## A4LD UPDATE HANDBOOK INDEX

AUTOMATIC TRANSMISSION SERVICE GROUP  
9200 S. DADELAND BLVD. SUITE 720  
MIAMI, FLORIDA 33156  
(305) 670-4161

Updated  
April, 2004

Figure 13

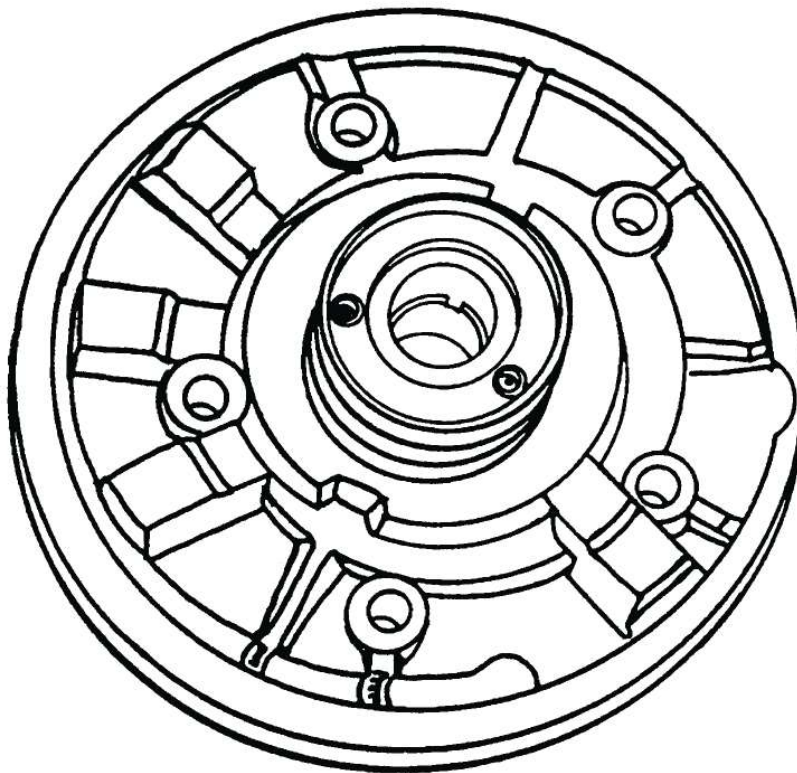
**CHANGE:** The rear input shaft bushing location was moved closer to the top of the stator.

STATOR SUPPORT - The stator support wall was made thicker to accommodate the change in the bushing location (See Figures 12 and 13).

Figure 14

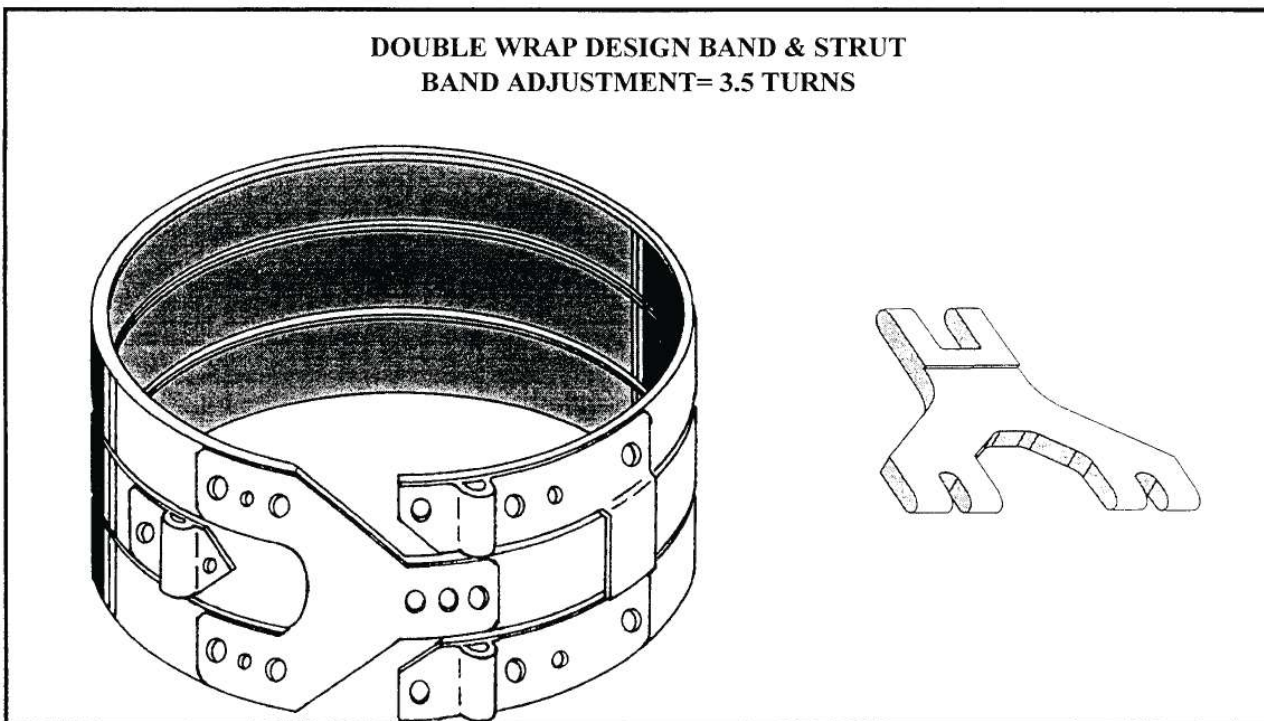
**CHANGE:** Beginning in model year 1990, on 4.0L models, a "double wrap" overdrive band was introduced.

(1) OVERDRIVE BAND - Was changed to a double wrap design band (See Figure 14).

(2) BAND APPLY STRUT - Was redesigned to accommodate the double wrap band (See Figure 14).

The previous design overdrive band will interchange provided both the previous design band & strut are used together (See Figure 15). Band adjustment must also be changed if the early design band is to be used.

Figure 22

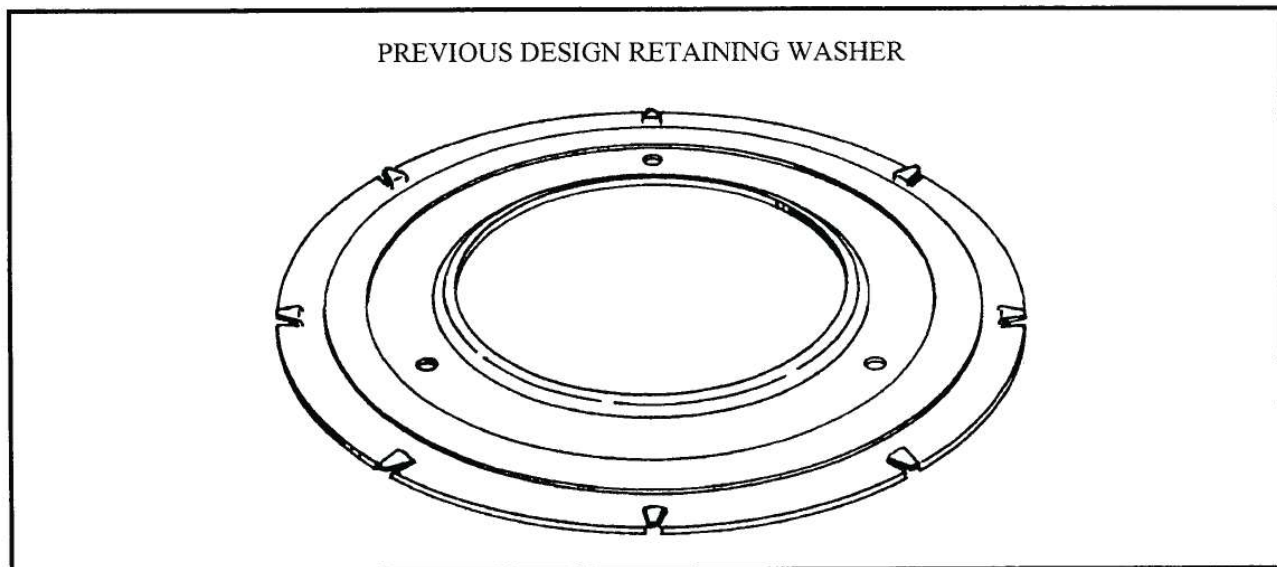
**CHANGE:** Vehicles equipped with A4LD transmissions built after June 9, 1992 contain a plastic caged overdrive sprag assembly that is no longer serviced. The previous design steel caged sprag and all related parts must be used for service (See Figure 24).

- (1) **OVERDRIVE SPRAG ASSEMBLY** - Previous design steel caged sprag must be used, as the plastic caged sprag is no longer serviced, which requires the use of the previous design ring gear and the previous retaining washer (See Figure 22).
- (2) **OVERDRIVE RING GEAR** - Previous design ring gear must be used to accommodate the steel caged sprag and retaining washer that must be used. Measure the overdrive ring gear, as shown in Figure 23, to ensure you have the proper one.
- (3) **RETAINING WASHER** - Previous design retaining washer shown in Figure 22 must be used to accommodate the previous design overdrive ring gear.

Overdrive Sprag Assembly (Previous Design) .....E5TZ-7A089-A  
 Overdrive Ring Gear (Previous Design) .....E5TZ-7A153-A  
 Retaining Washer (Previous Design) .....E7TZ-7L339-A

Figure 25

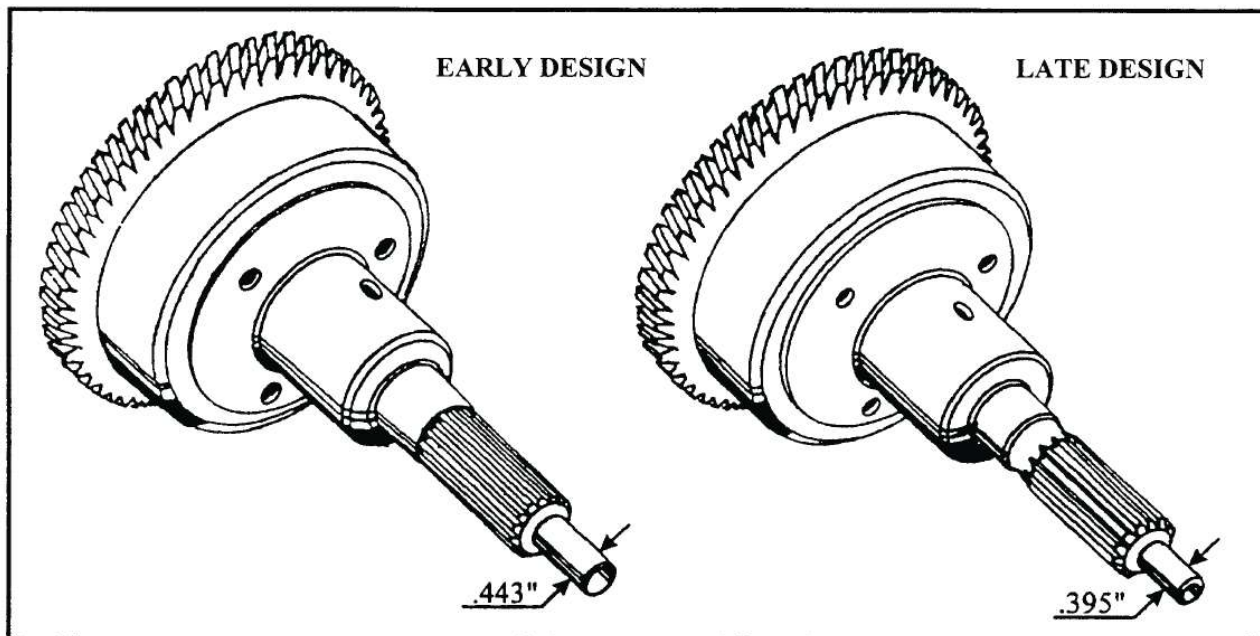
**CHANGE:** Beginning in model year 1990, on 4.0L models, the O.D. center shaft pilot was machined .048" smaller in diameter.

- (1) O.D. CENTER SHAFT - The diameter of the pilot on the shaft was machined .048" smaller than the previous design, to accommodate the bearing added to the output shaft. The new design pilot diameter is .395", and the previous design pilot diameter is .443". (See Figure 25)
- (2) OUTPUT SHAFT - Previous design bushing was replaced by a caged needle bearing. (See Figure 26). The caged needle bearing is not serviced separately from Ford Motor Co.

Caged Needle Bearing.....INA-1010

Figure 27

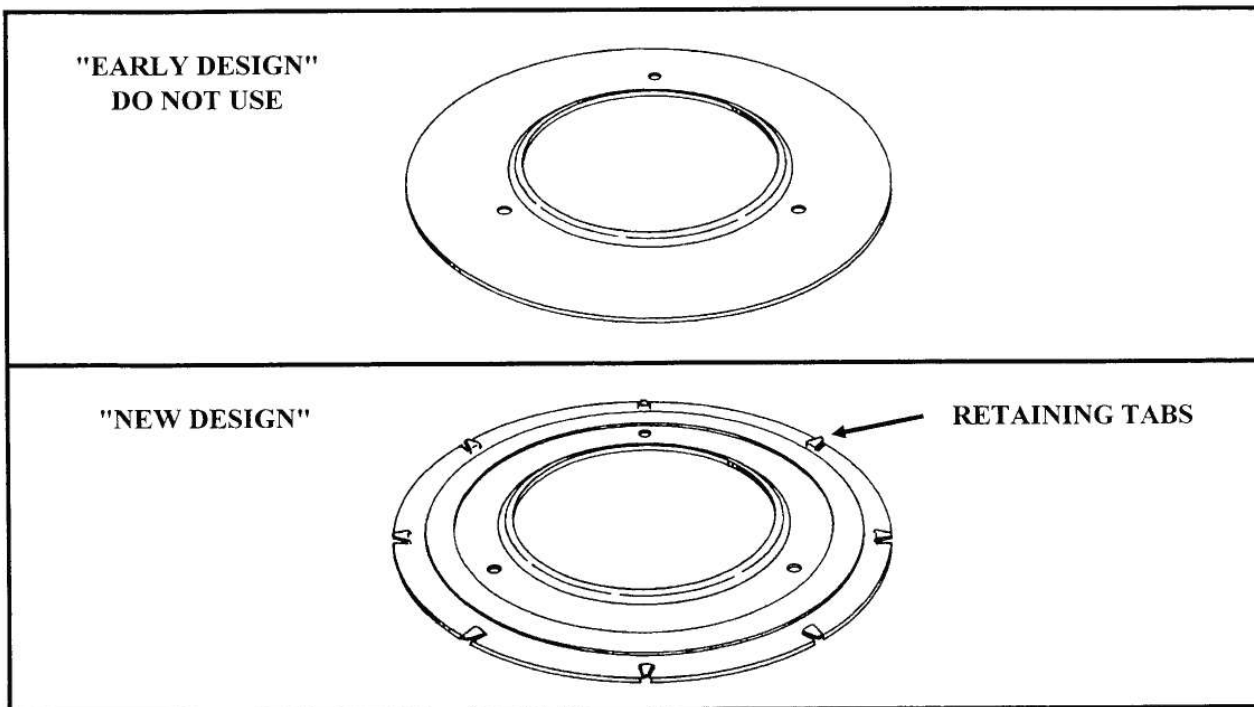
**CHANGE:** The overdrive sprag retaining washer was changed, sometime in model year 1987, in vehicles equipped with A4LD transmissions.

- (1) OVERDRIVE SPRAG RETAINING WASHER - The new design retaining washer increased in overall diameter and has retaining tabs stamped into it to prevent the washer from rotating in the overdrive ring gear. (See Figure 27).

Retaining Washer (New Design).....E7TZ-7L339-A

Figure 29

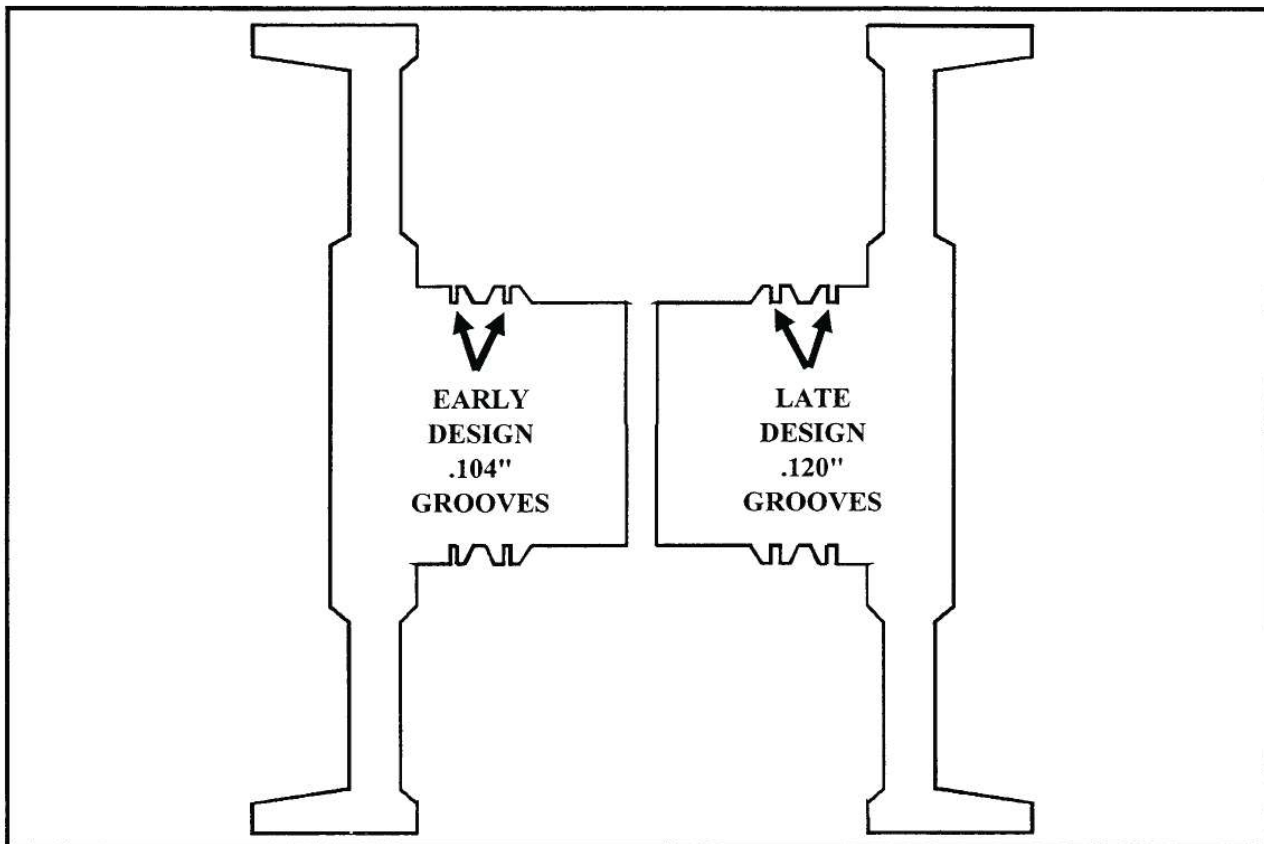
**CHANGE:** Sealing ring grooves were widened from .104" to .120", and the OEM part number did not change.

- (1) CENTER SUPPORT - The sealing ring grooves were widened from .104" to .120" (See Figure 29).
- (2) SEALING RINGS - The sealing rings were widened to fit the larger ring grooves.

The center supports are interchangeable, however, you must use the correct size rings for the center support you are using.

Figure 31

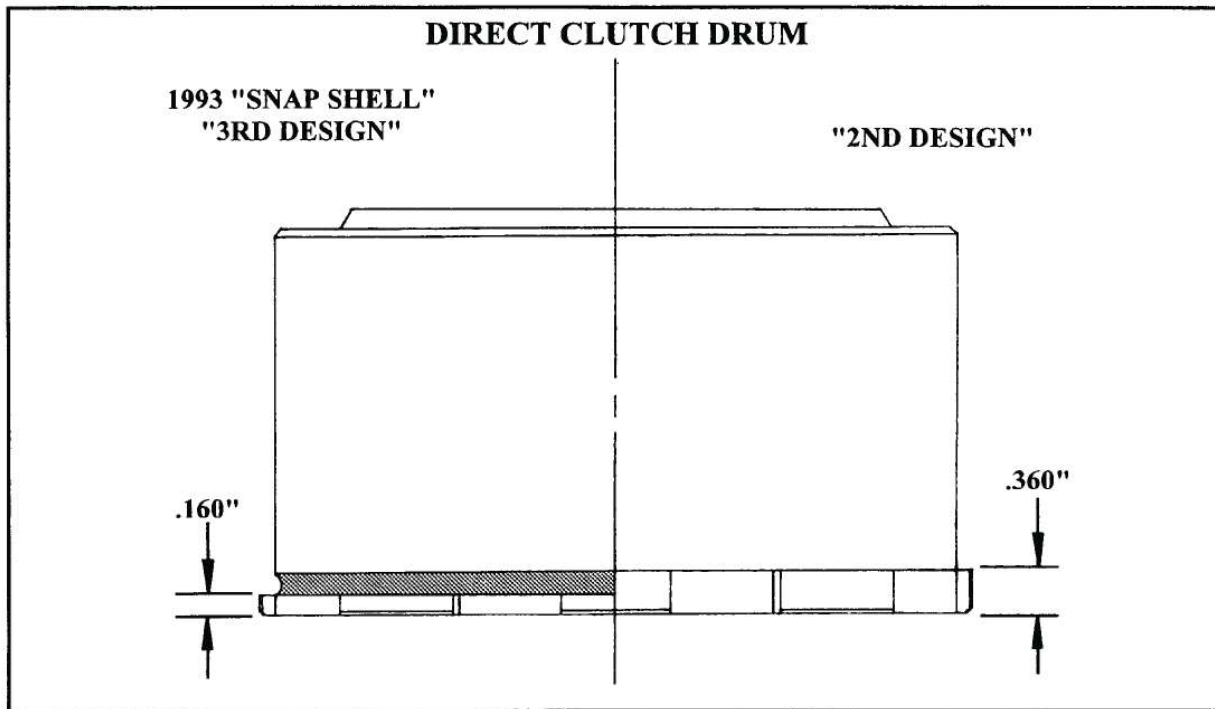
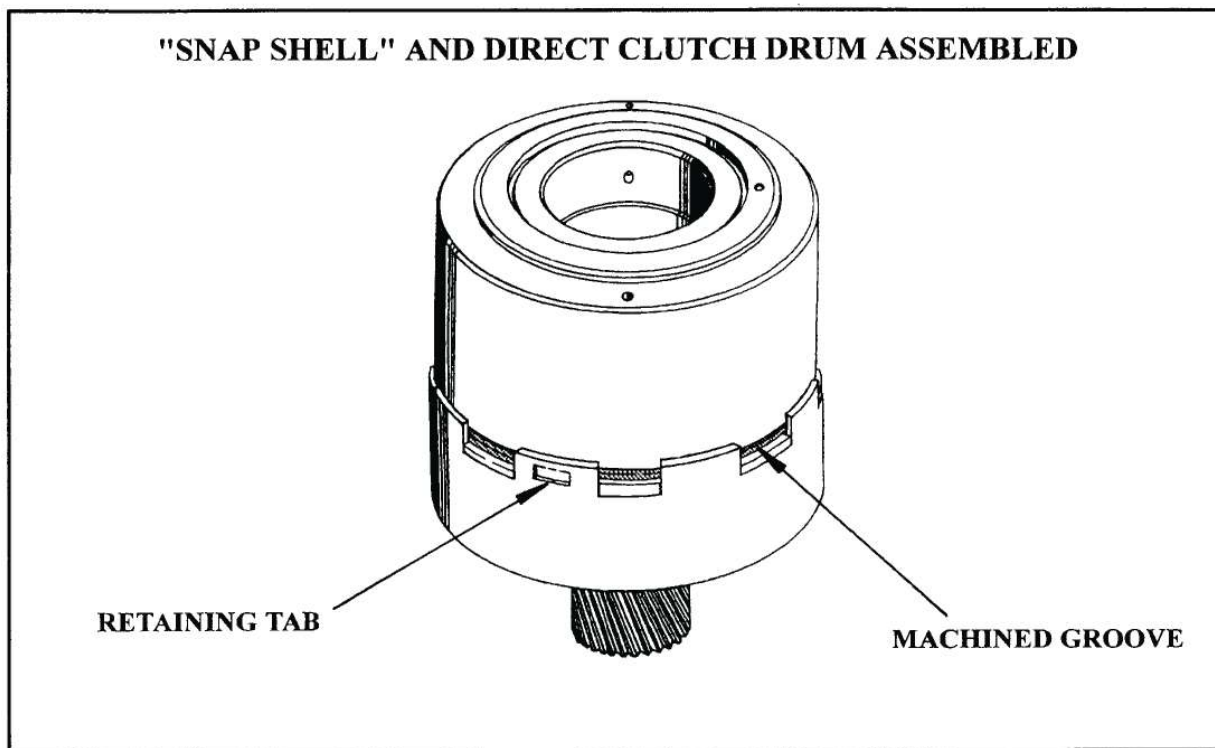
**2nd Change:** The "Lug" area where the direct clutch drum engages the sun gear shell, was machined approximately .200" thinner, and a .050" deep groove was machined into the drum to accommodate the added retaining tabs on the "Snap Shell" (See Figure 31). This now allows the sun shell and the direct drum to "Snap" together for easier assembly (See Figure 32). This change also allows the elimination of the number 4 thrust washer, located between the direct clutch drum and center support.

- (3) The new design "Snap Shell" must only be used with the direct clutch drum that is machined to accept the retaining tabs (See Figure 31 and 32).
- (4) The "3rd Design direct clutch drum **WITH** the machined groove for the "Snap Shell" **WILL** retro-fit back to **ALL** previous models that do not use "Snap Shell" (Figure 31). The "1st Design" stamped steel direct clutch drum is not recommended for use.

Figure 33

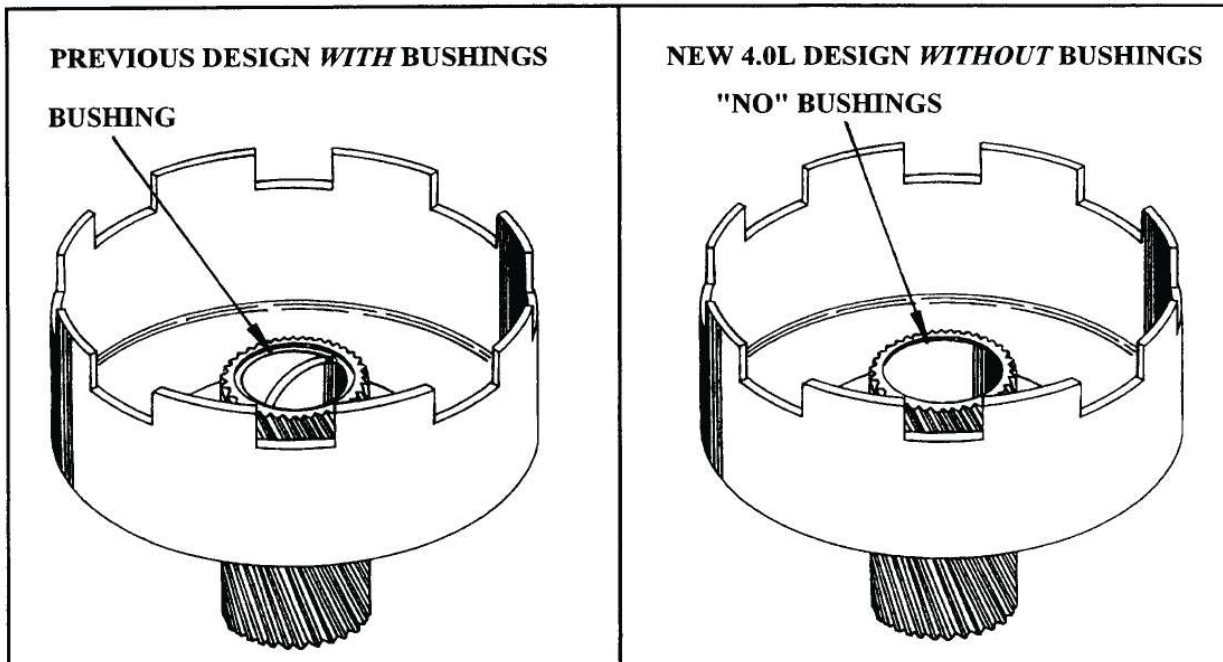
- (2) **SUN GEAR** - Both bushings, inside the sun gear, were eliminated to allow full lubrication flow to the front planetary (See Figure 33).
- (3) **SUN GEAR SHELL** - "Snap Shell" was introduced in 1993 4.0L models, and has two retaining tabs stamped into the sides 180° apart, as shown in Figure 34. These tabs are used to retain the new direct clutch drum in the sun gear shell. The flat steel thrust washer (No. 14) on the back side of sun gear shell was eliminated when the sun gear bushings were eliminated.

- (1) The new design sun gear **WITHOUT** bushings **WILL** retro-fit back to all previous models (See Figure 33).
- (2) The previous design sun gear **WITH** the bushings **CANNOT** be used forward into the 4.0L models (See Figure 33).

Figure 35

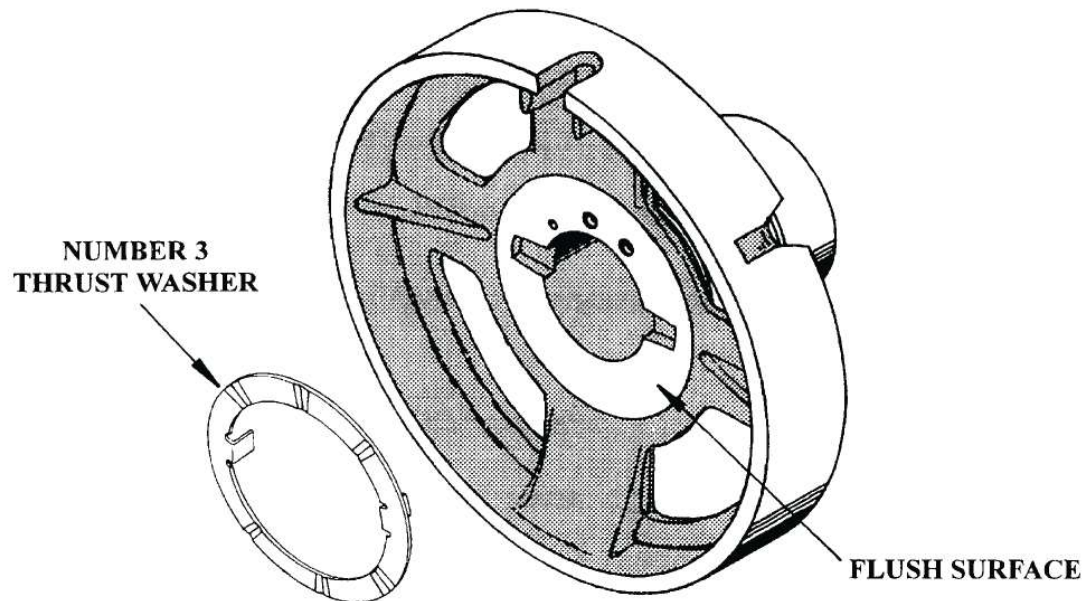
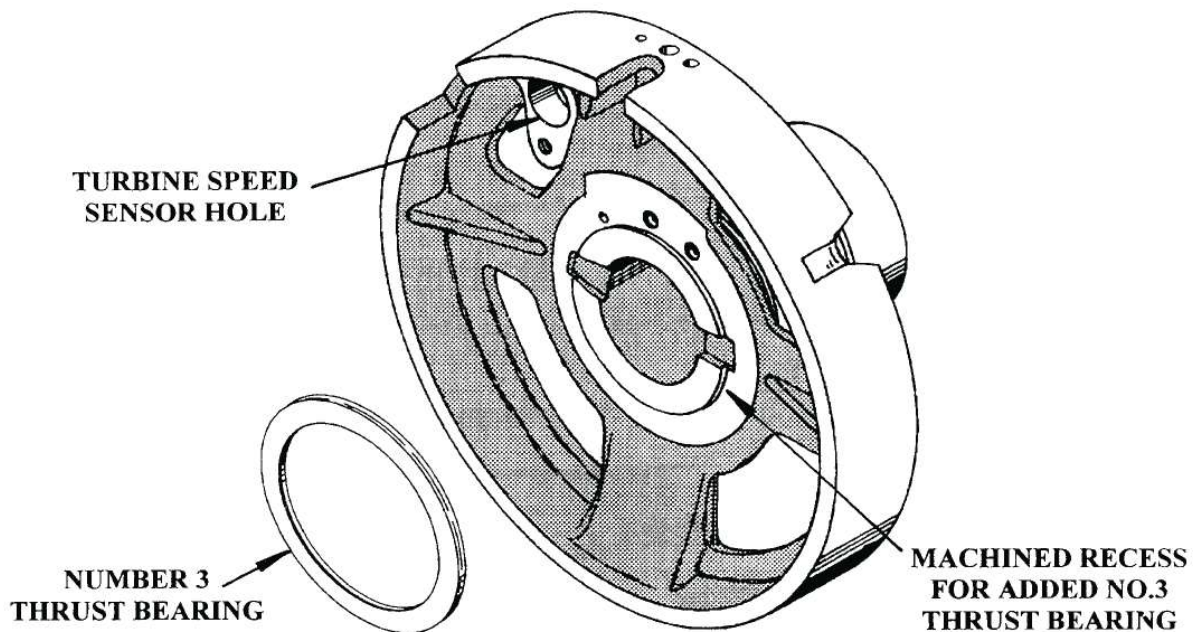
- (4) **CENTER SUPPORT** - When the "Snap Shell" was introduced in 1993, the number 3 thrust washer was eliminated (See Figure 35), & number 3 thrust bearing was added (See Figure 36). The addition of the number 3 thrust bearing required machining the surface deeper to accommodate the bearings added thickness (See Figure 36).  
The new design center support also has a machined recess at the base of the sealing ring hub to accommodate the newly added number 5 thrust bearing (See Figure 38). Remember, the number 4 thrust washer was eliminated when this change occurred (See Figure 37).  
There are four easy ways to identify the new design center support:

1. Machined recess for added number 3 thrust bearing (See Figure 36).
  2. Machined recess for added number 5 thrust bearing (See Figure 38).
  3. Machined hole for turbine speed sensor getting ready for 4R55E (See Figures 36 and 38).  
NOTE: Some new design center supports are cast for, but no hole has been machined.

- (6) The previous design center support **CANNOT** be used forward into **ANY** model that is using the "Snap Shell" (See Figure 35).
- (7) The new design forward clutch drum **WILL** retro-fit back on **ALL** previous models. (See Figure 39).
